Share Deficiency Cases in Belgium/Netherlands

(Updated on 2023.05.12)

Figure 1

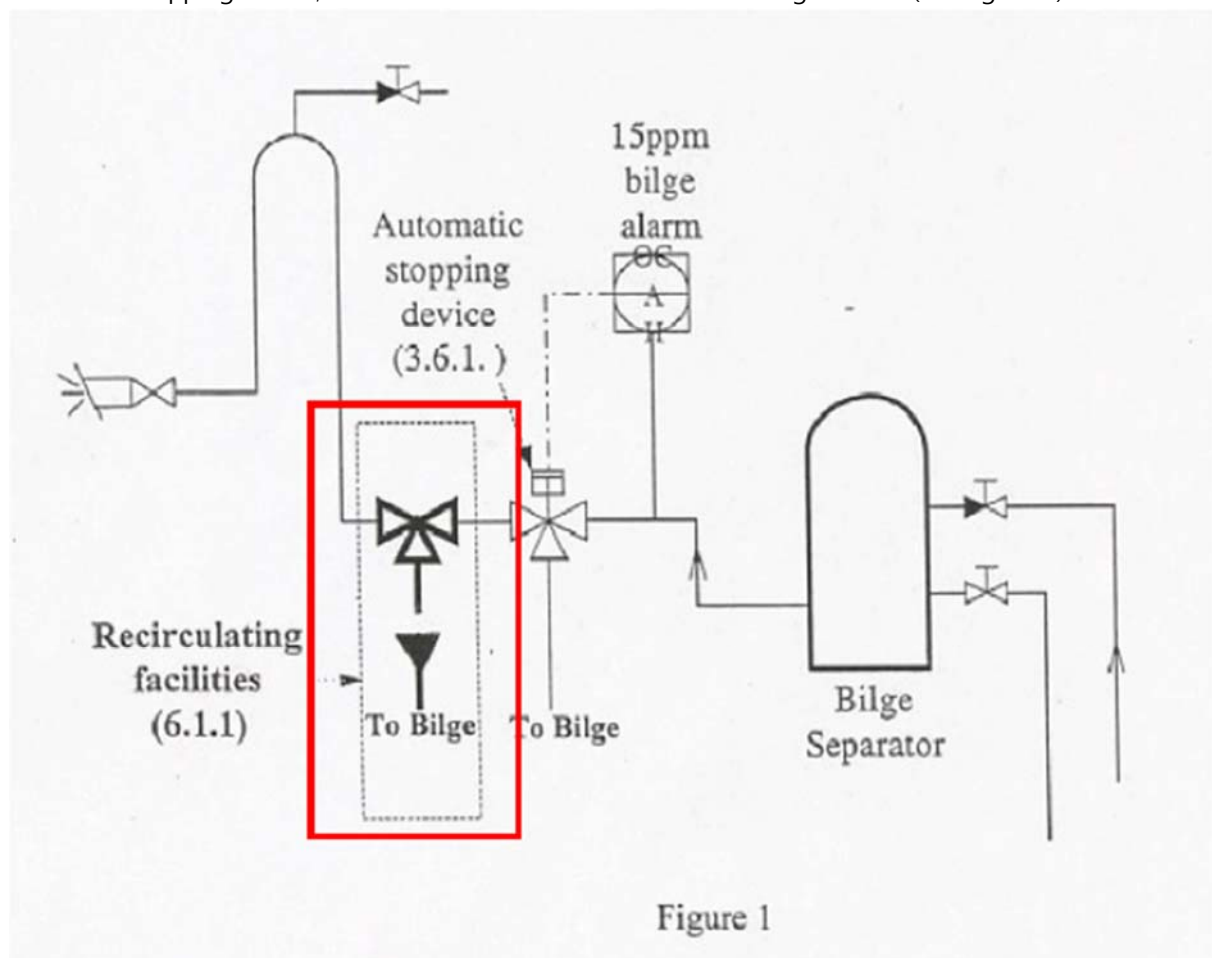
The filtering equipment (piping) is not installed compliant to MEPC 107. At 3-way valve outlet OWS to overboard/ return to bilge tank. On the line to bilge tank (recirculation facilities 6.1.1) there is no funnel or sight glass provided to observe full opening or closure of the automatic 3-way valve (automatic stopping device 3.6.1) behind the OWS. Ch. Eng Stated the company already is investigating the lay out by installing a sample valve/Line. This is not correct as the interruption of the flow is to be verified. [QUOTE MEPC.107(49)]

6.1.1 For future inspection purposes on board ship, a sampling point should be provided in a vertical section of the water effluent piping as close as is practicable to the 15 ppm Bilge Separator outlet. Re-circulating facilities should be provided, after and adjacent to the overboard outlet of the stopping device to enable the 15 ppm Bilge Separator system, including the 15 ppm Bilge Alarm and the automatic stopping device, to be tested with the overboard discharge closed (see figure 1).
